October 20, 2014

Re: Comparison letter for MegaMet's MegaStorm Door against door construction details in FEMA 361 section 7.4.1

Reference: P.O # 110513

NAME:	320 DOOR CONSTRUCTION

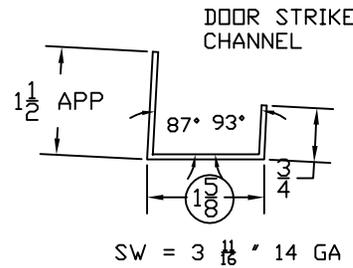
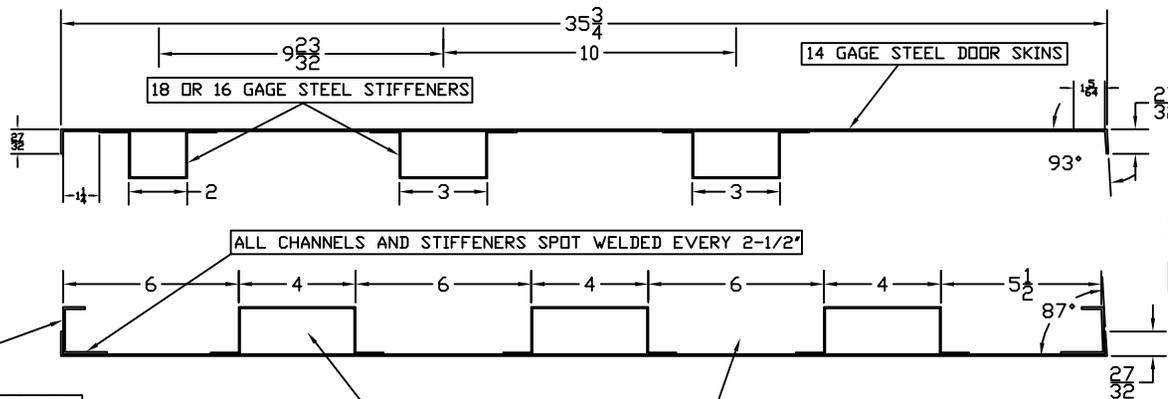
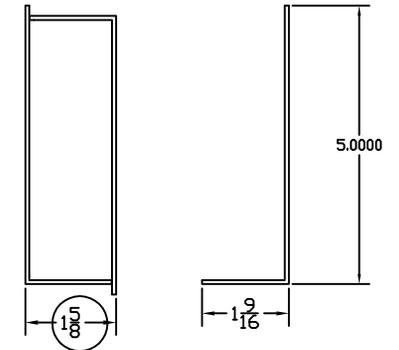
A detailed comparison of the construction recommendations in FEMA 361 section 7 and MegaMet's MegaStorm Door is provided in Table 1. The MegaStorm single and double doors in configurations per the attached drawing details provided by MegaMet (with mark-ups) exceeds the construction recommendations described section 7.4 in FEMA 361 with the following limitations and stipulations:

- The door width is equal or less than 36 inches
- The door hardware which consists of latching locking mechanisms and hinges must be specified only with certified and approved for FEMA's 361 Safe Rooms.

6'0 x 8'0 FEMA 361

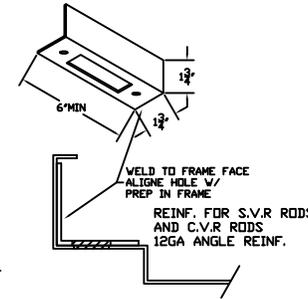
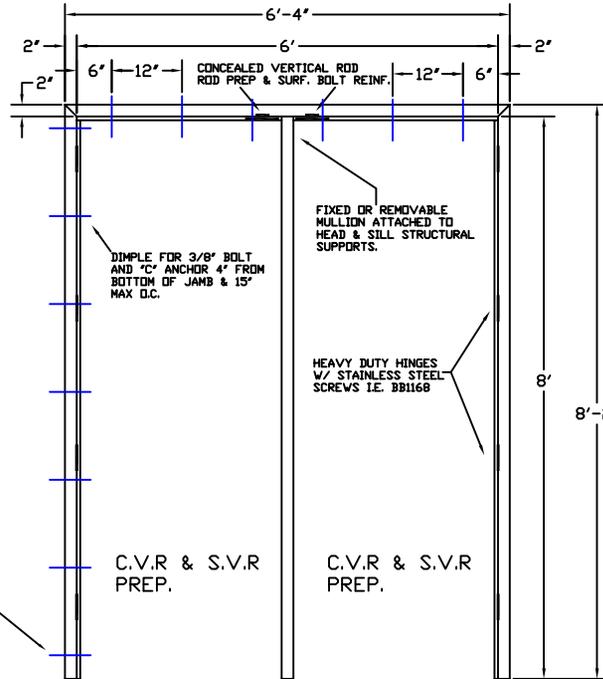
- Each leaf to be 36 inches wide or less in a swing-out configuration
- Hardware per requirements mentioned above for Single Doors
- Must have a fixed or removable middle mullion consisting of structural steel tube section or with structural reinforcement within the mullion.
- The middle mullion must be properly attached at the head and sill and shown through testing of analysis to be capable of resisting the wind pressures and missile impact demands.
